FIELD SERVICE BULLETIN

SERVICE DEPARTMENT
CONSOLIDATED VULTEE AIRCRAFT CORPORATION
San Diego, California, U.S.A.

October 15, 1944

Figure 9. Revised Aileron and Aileron Tab Control Systems

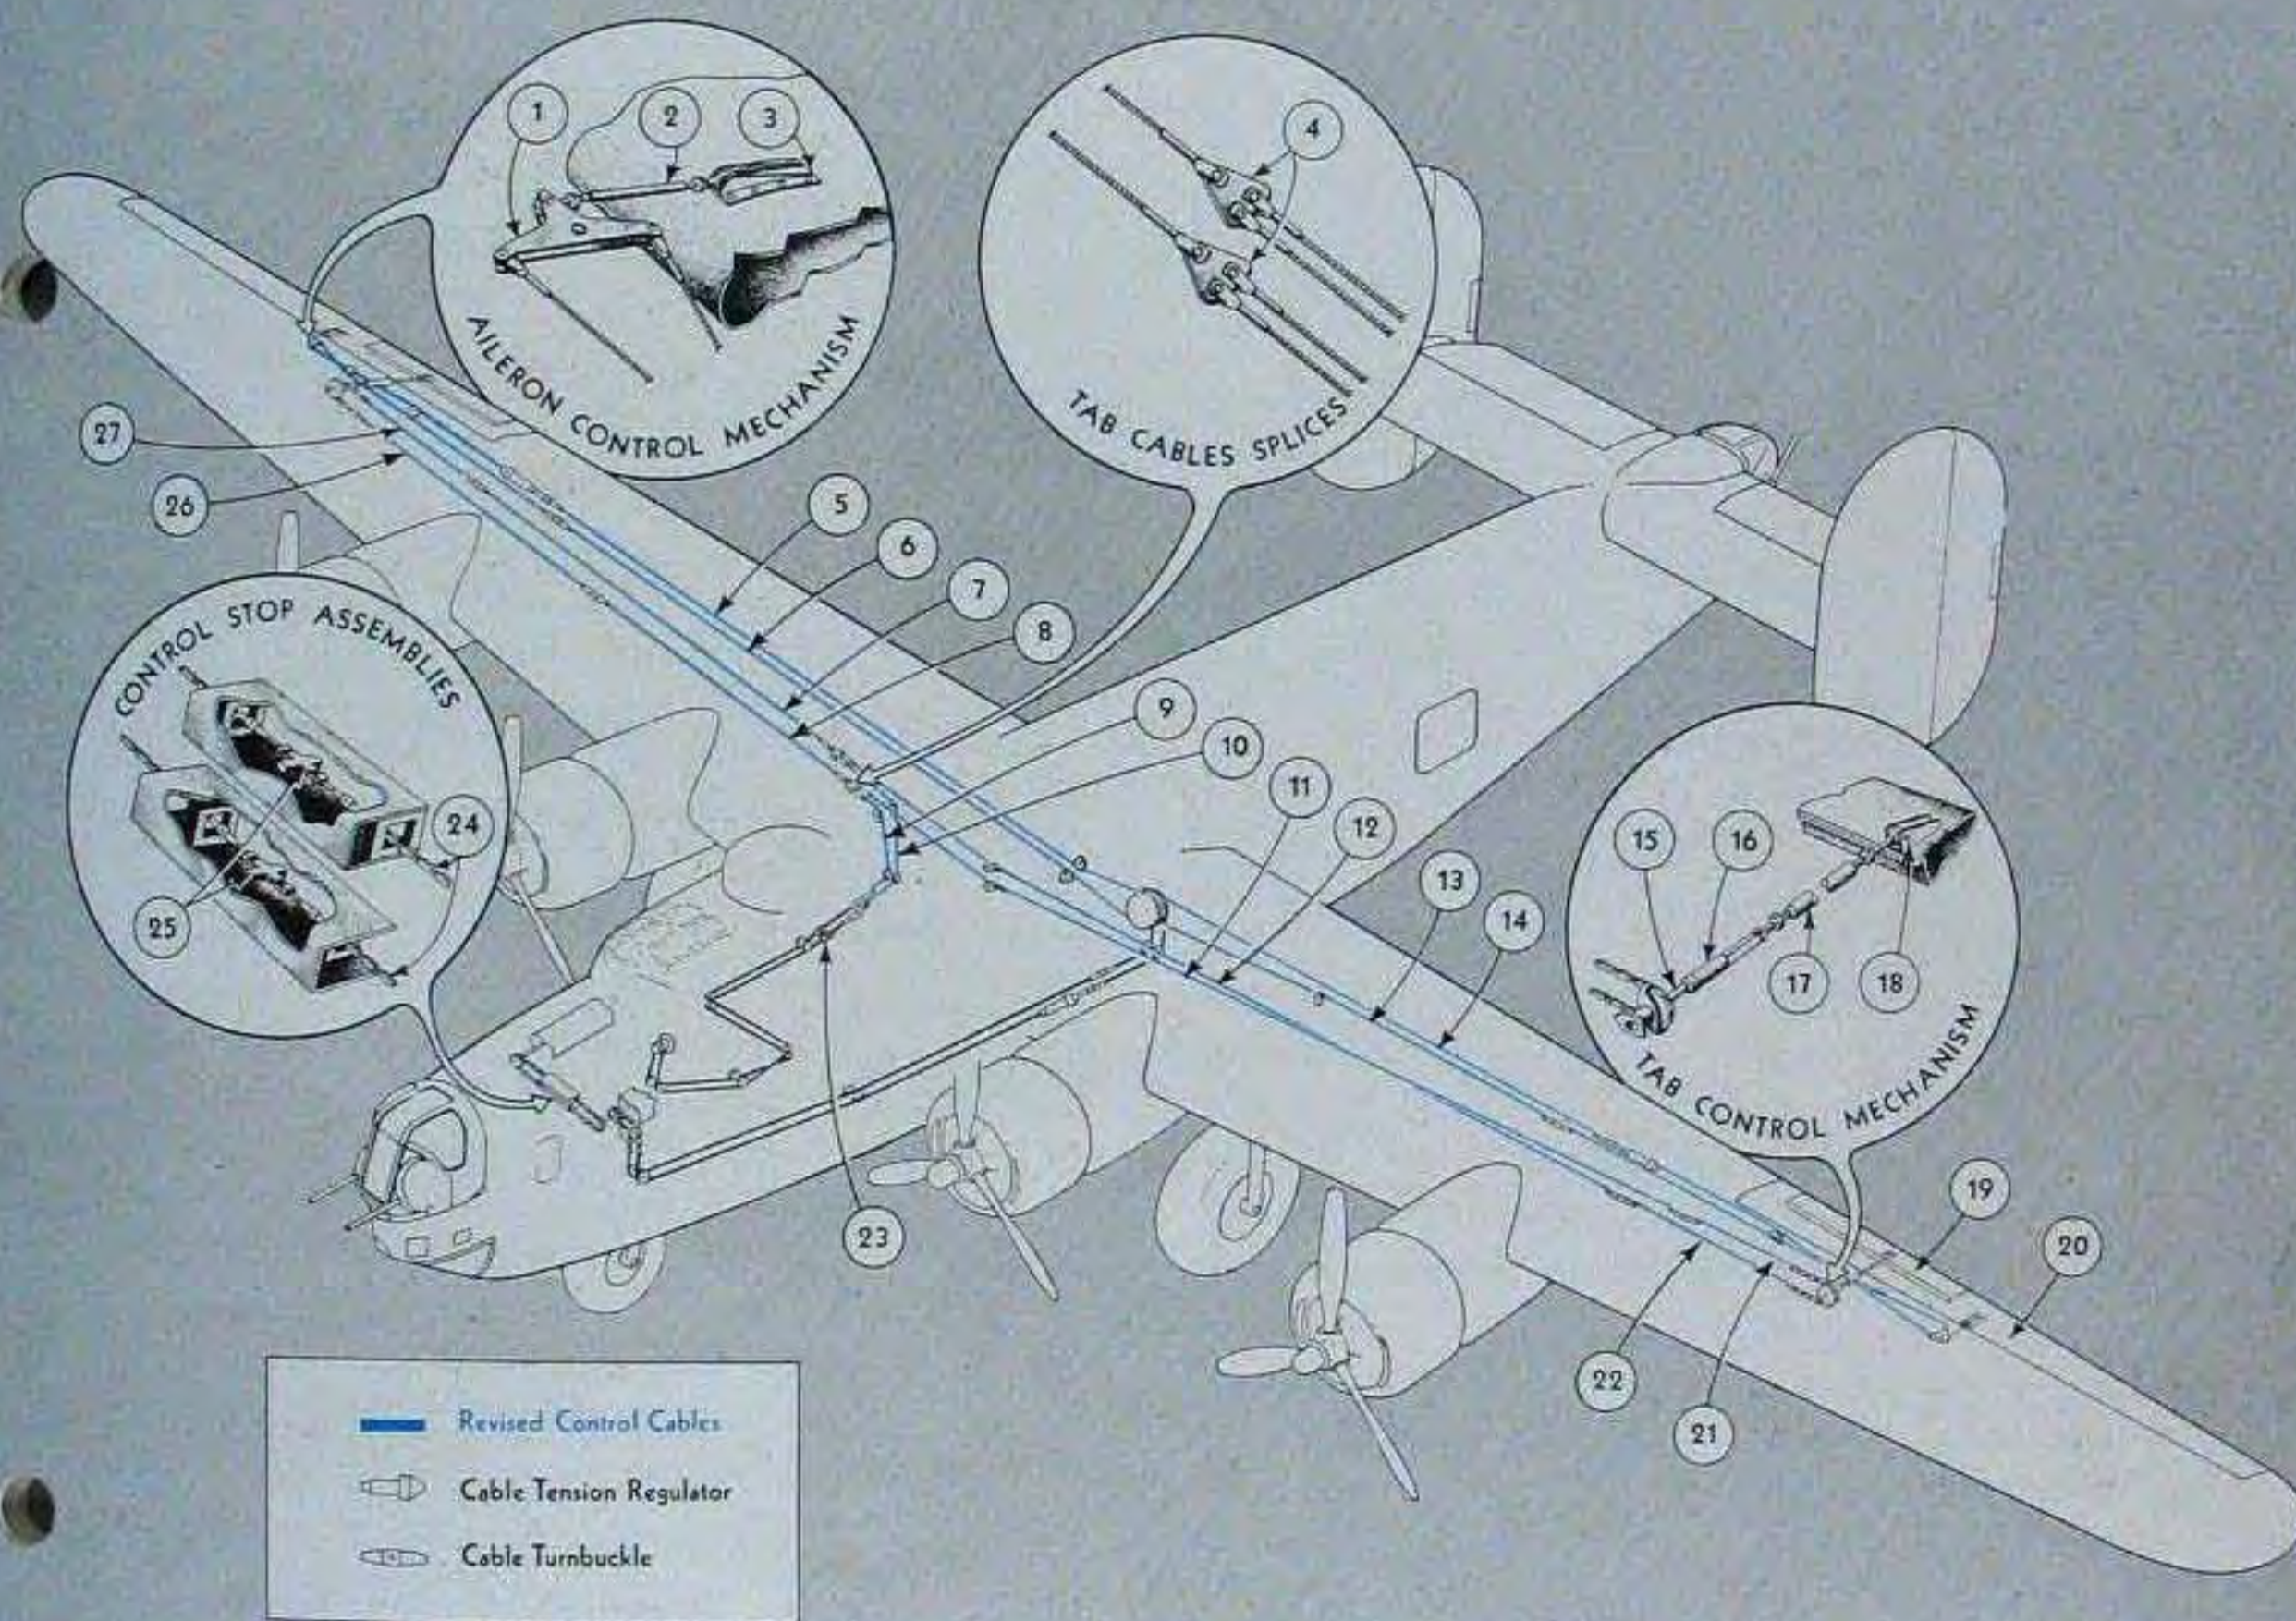
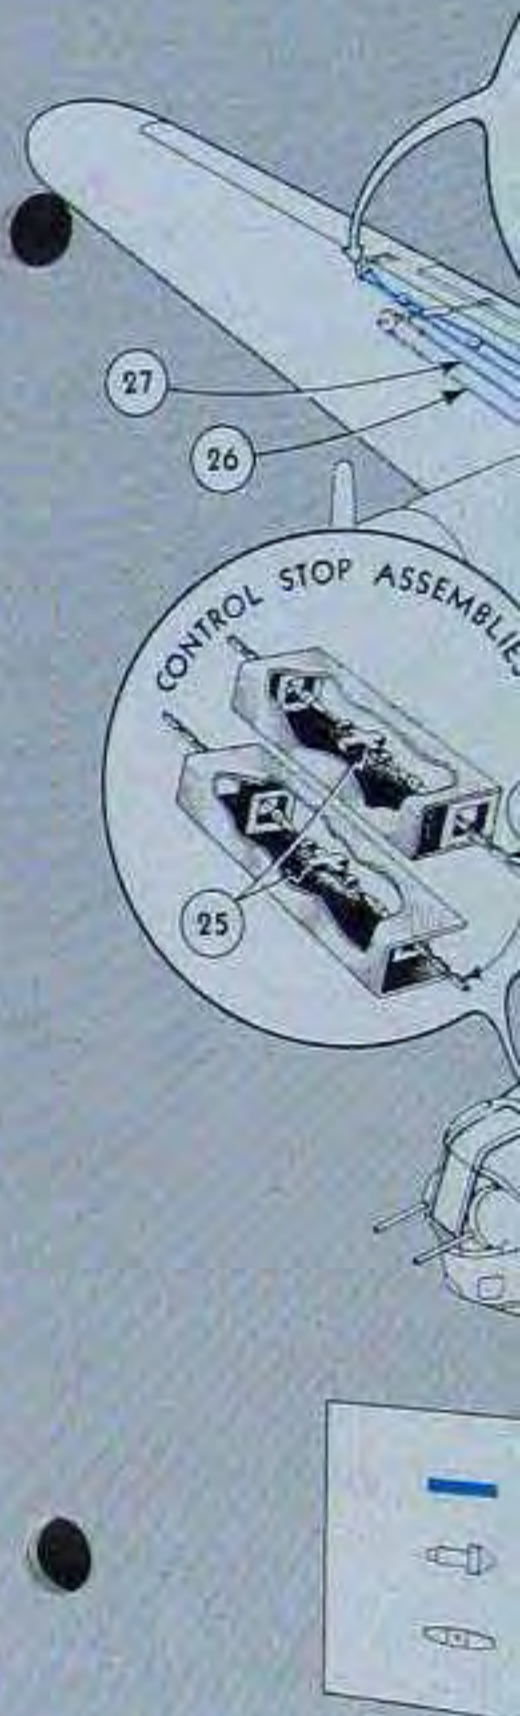
THE aileron and aileron tab control systems have been modified so as to incorporate a tab in the left aileron and to provide for the installation of bell cranks in place of aileron gear boxes. (Refer to figure 9.)

A TAB (19) (32W1315L) has been added to the left aileron (20) (32W573-4L) to improve the effectiveness of the aileron tab system. The need for more tab surface has developed as a result of the increase in gross weight and engine power, and the addition of auxiliary wing fuel cells. The single aileron tab installation was suitable for the B-24 airplane of 41,000 lbs. gross weight (original B-24 specification).

Control cables for the left aileron tab (11), (12), (21) and (22) have been added and are connected to the right aileron tab cables (7), (8), (26), and (27) near station 3.0 on the right wing. A connector (4) splices the tab cables in the wing to the tab cables (9) and (10) in the fuselage.

Aileron tab cable stops (23), located in the right forward bomb bay are adjusted to allow a 10° up and down movement of the tabs.

The control mechanisms (32C4546) (refer to inset) for the aileron tabs have been changed to provide a 15°

servo action of the tabs when the ailerons are deflected 20° (aileron deflection limit 20° up, 20° down). The former tab control mechanism (32W586) did not provide servo action. The universal joint has been removed from the revised tab control mechanisms.

The revised installation provides a single bell crank (1) and aileron horn (3) for each aileron. The single point control installation reduces operating friction and simplifies installation of the aileron control system. The bell crank installation requires less movement of control cables to obtain a full deflection of the ailerons. Consequently, the maximum turning limit of the pilot's aileron control wheel has been reduced. A revised aileron control stop assembly (refer to inset) has been installed in the aileron control chain assembly (24) which connects the pilot's and copilot's control columns.

INCORPORATION of the single horn installation on the ailerons has necessitated a change of the aileron structure to distribute the concentrated load of the single control horn.

The outer wing panel rear spar has been changed to accommodate the bell crank installation. Slots cut in the rear spar allow passage of the bell crank and cables. Reinforcing angles have been added adjacent to the slots to maintain the required strength of the spar.

Figure 11. Wiring Diagram for No. 1 Generator Circuit

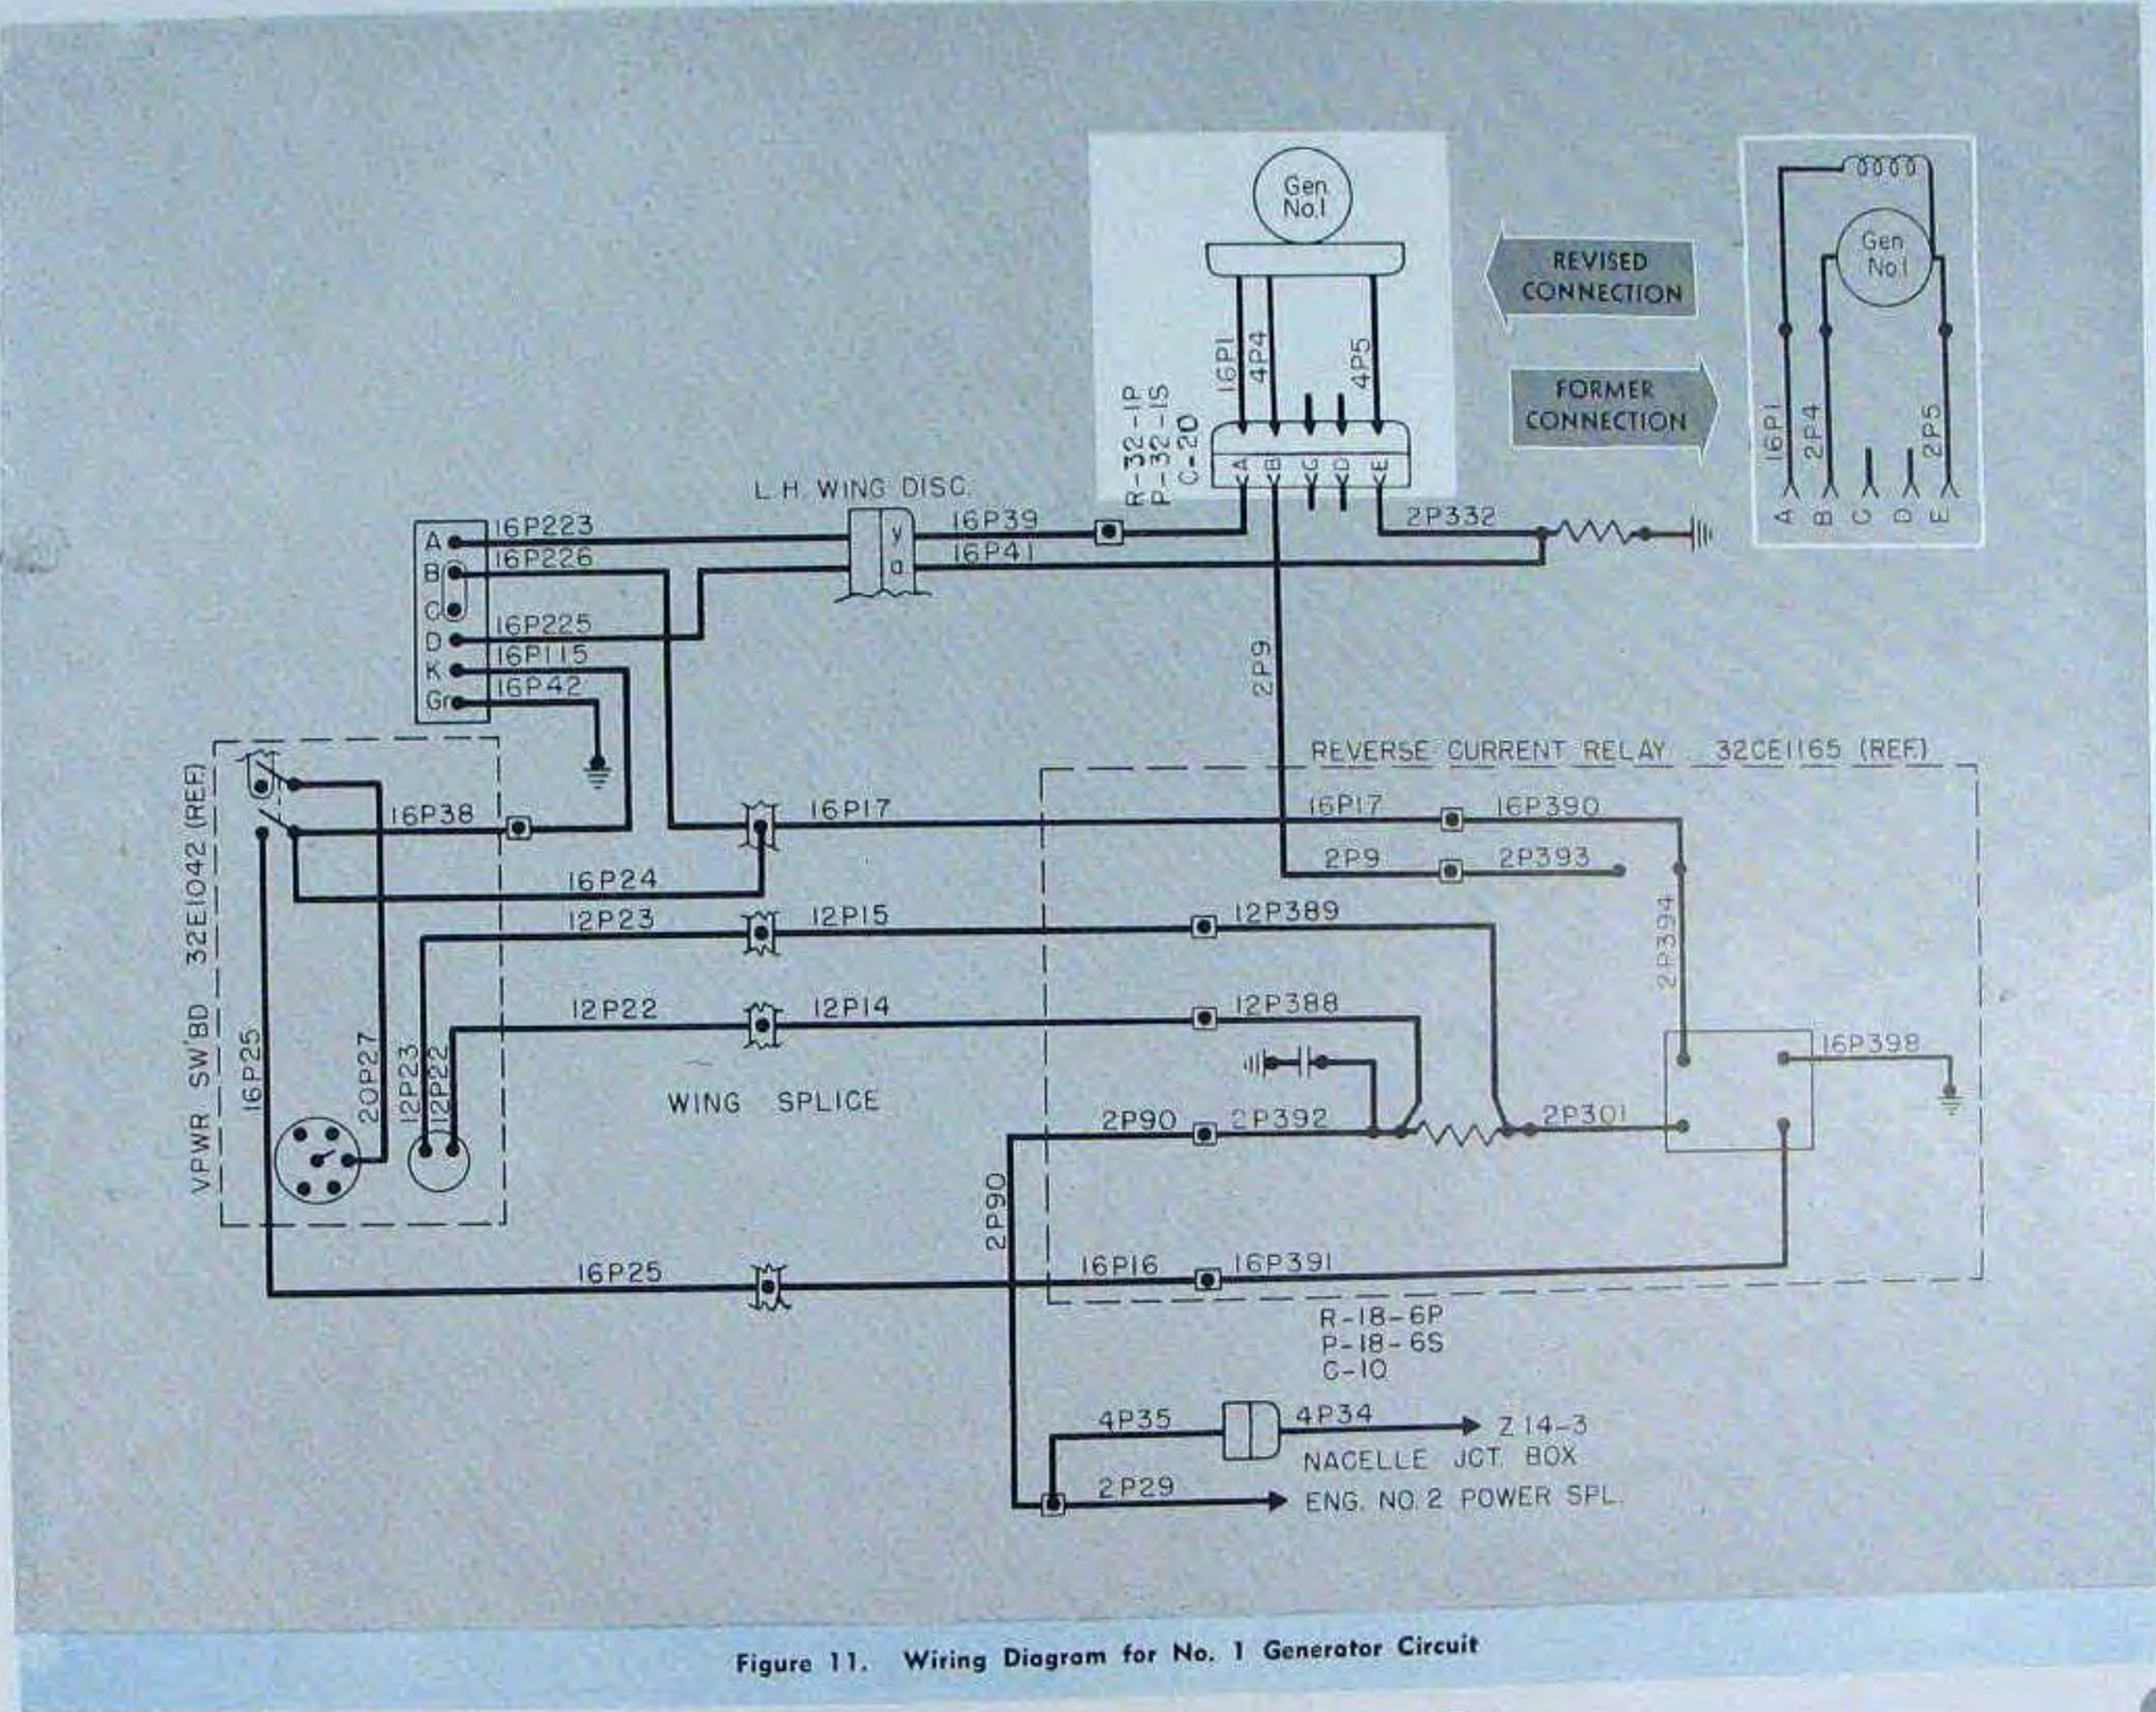
The type O-1 generator, manufactured by the Leece-Neville Co. of Cleveland, Ohio, (figure 12) is interchangeable with the P-1 generator except that they require different type resistors. Resistor (RES-8-60-FW) is used with the 100 ampere generator, and resistor (RES-8-50-FW) is used with the 200 ampere generator. Necessary changes were made in wiring sizes to accommodate the smaller generator (figure 11).

Figure 12. Type O-1 Generator Installed

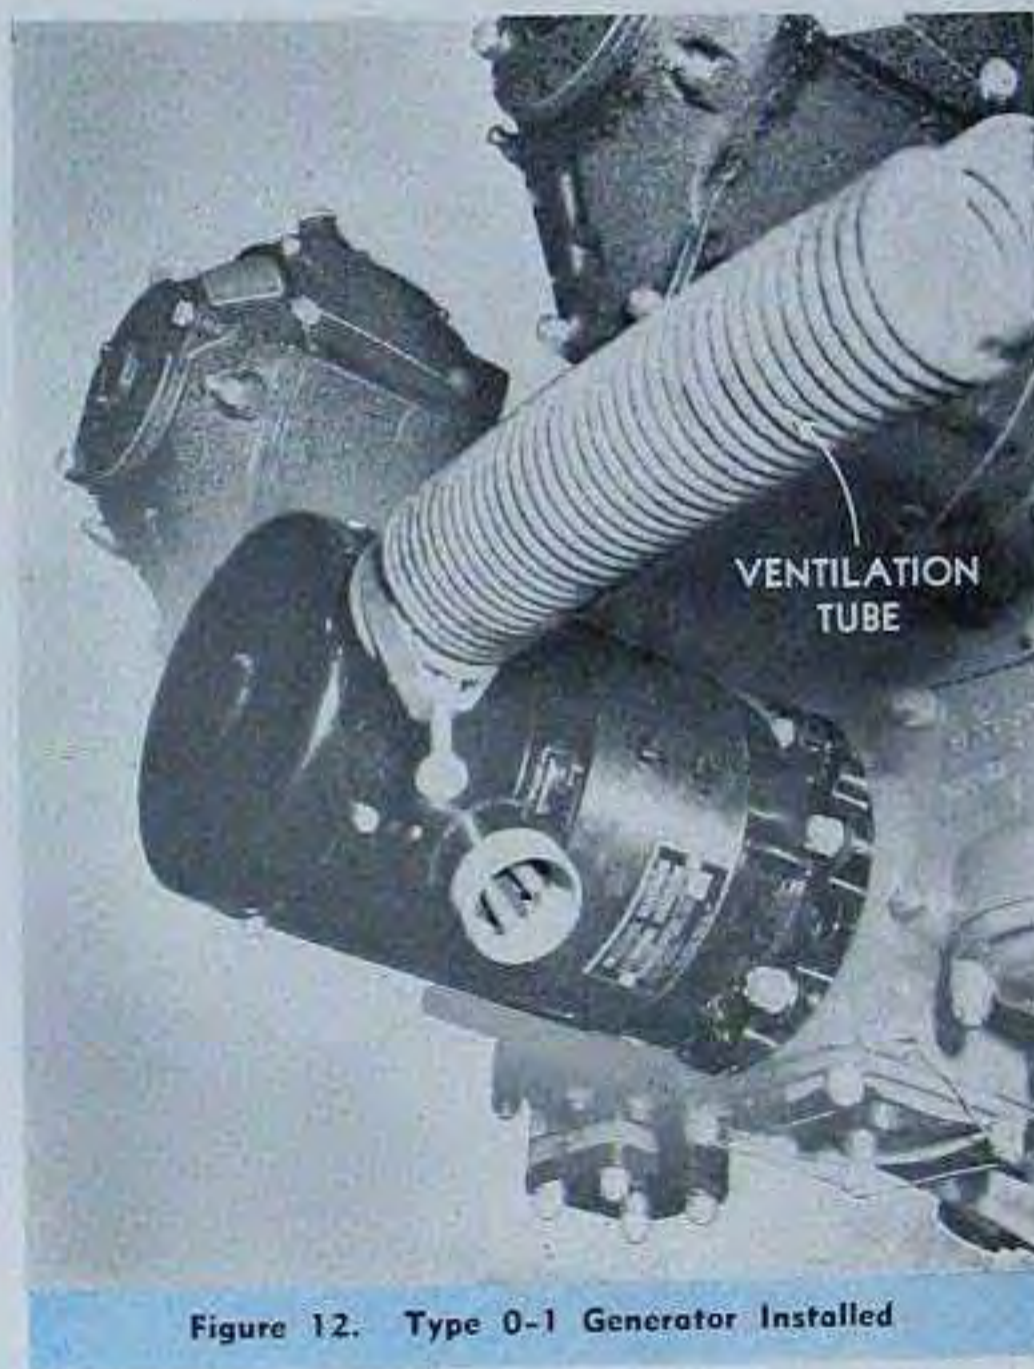
THE type P-1 (200 ampere) generator has been replaced with type O-1 (100 ampere) generator on C-87 airplanes beginning with A.A.F. Serial No. 44-39265.

The ventilation tube (figure 12) is connected at the air blast cover and leads to a suitable air intake duct.
